**PCN# : P632AAB**  
**Issue Date : Apr. 01, 2016**

**Information Only Notification**

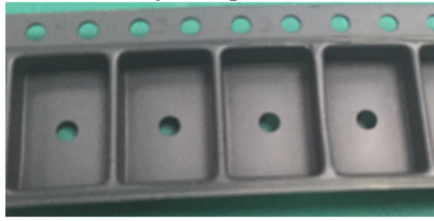
TO252 devices packed by standard carrier tape without stop bar in cavity.

TO263 devices packed by standard carrier tape without corrugated and emboss design.

TO252 devices packed by carrier tape with stop bar in cavity.(FSZD-4-0023)

TO263 devices packed by carrier tape with corrugated and emboss design.(FSZD-4-0024)

Key dimension "F" and "P1" are no affected.

TO252: Adding a stop bar to prevent lead pierce through carrier tape during product transportation.

TO263: The change is to mitigate carrier tape deformation which result in lead bent during product transportation.
